Case # 19-02

SUBJECT: Proposed Revisions to Detail 200 Trench Backfill and Surface Replacement

Summary: Revisions to add joint sealant requirements, notes consolidation and other general cleanup.

"T TOP" TRENCH REPAIR

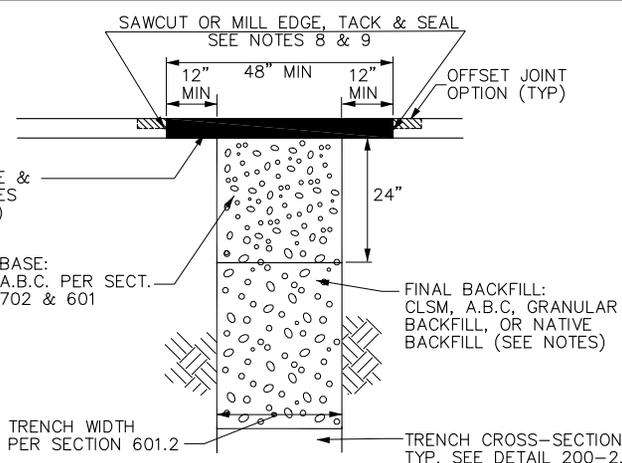
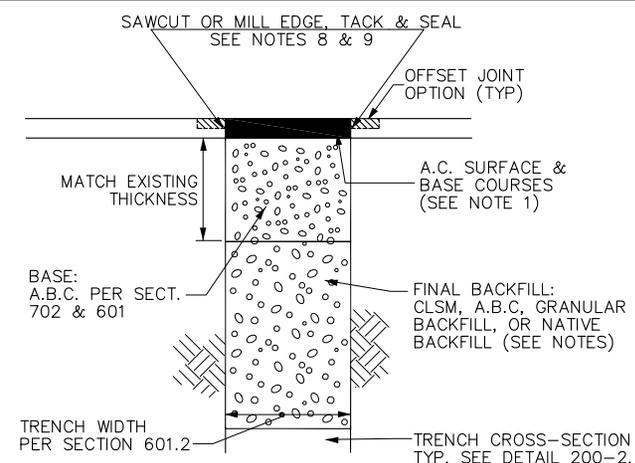
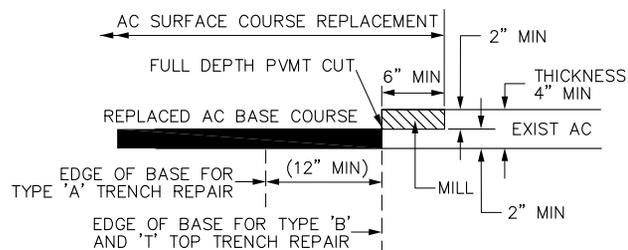
- Revised the sawcut and tack note on T-Top, Type A and B trench repair details to add back the 'OR MILL EDGE' that was unintendedly removed.
- Added the 'OFFSET JOINT OPTION (TYP)' note on T-Top, Type A and B trench repair details.
- Revised Note 2 adding 'TRENCH EXCAVATION, BACKFILLING AND' and 'NATIVE BACKFILL SHALL ONLY BE USED WITH AGENCY APPROVAL.'
- Revised Type E trench repair adding * to NATIVE BACKFILL within BASE and FINAL BACKFILL notes. Added callout note '*NATIVE BACKFILL WITH AGENCY APPROVAL TYP. WHERE ROADWAY IS NOT PLANNED FOR MORE THAN TWO YEARS.'

TRENCH CROSS-SECTION DETAIL

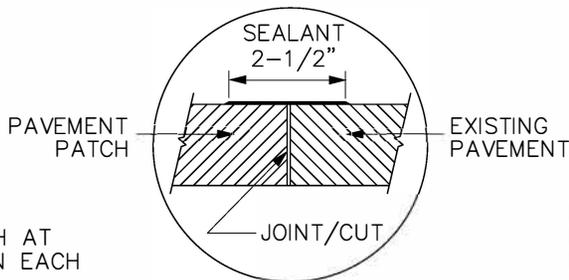
9. SAWCUT OR MILL EDGE AND APPLY TACK COAT. FOR PERMANENT PAVEMENT, APPLY 2-1/2" WIDE SECTION 337.2.1 COMPLIANT JOINT SEALANT AS REQUIRED BY AGENCY - SEE DETAIL ON 200-2.
